Technical Document FA19003

Part 2 – Technical Requirements

Application under the *Agricultural Operation Practices Act* for a confined feeding operation, manure collection area and/or manure storage facility(ies)

NRCB USE ONLY	Application number	Legal land description
	<input checked="" type="checkbox"/> Approval <input type="checkbox"/> Registration <input type="checkbox"/> Authorization <input type="checkbox"/> Amendment	<u>FA19003</u>

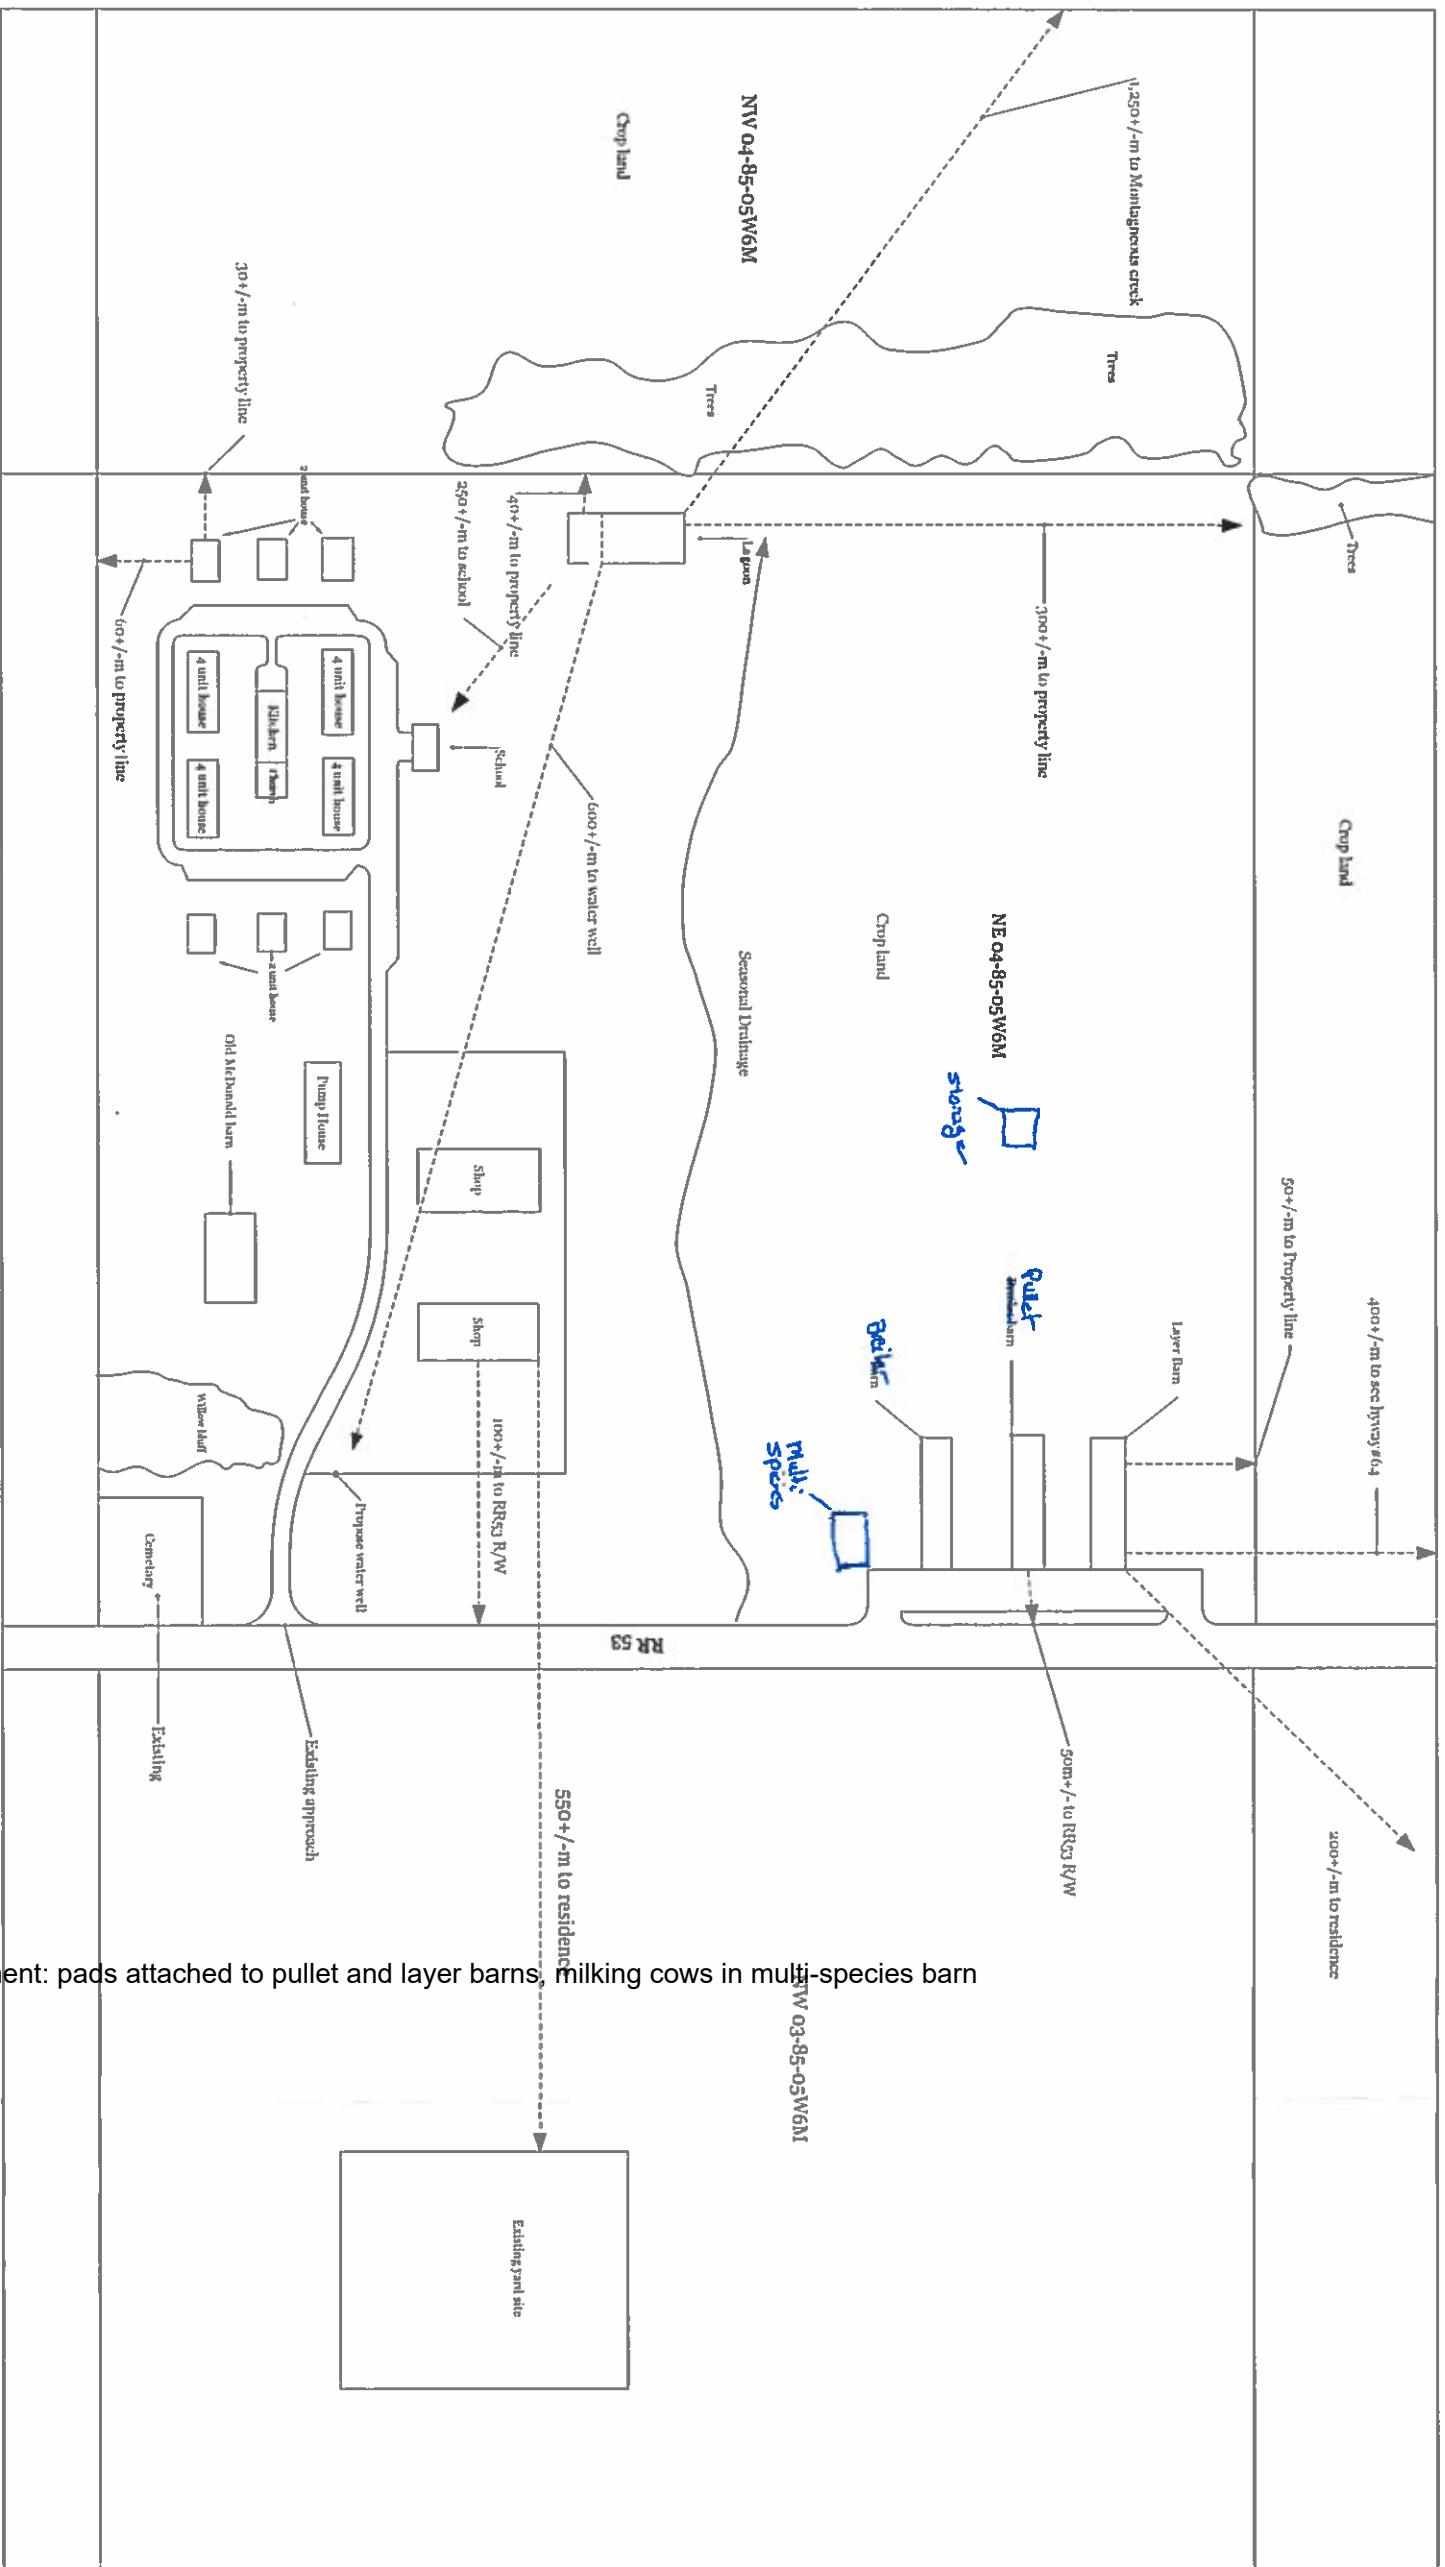
Comments:

Applicant to provide concrete documentation proving the type and strength.
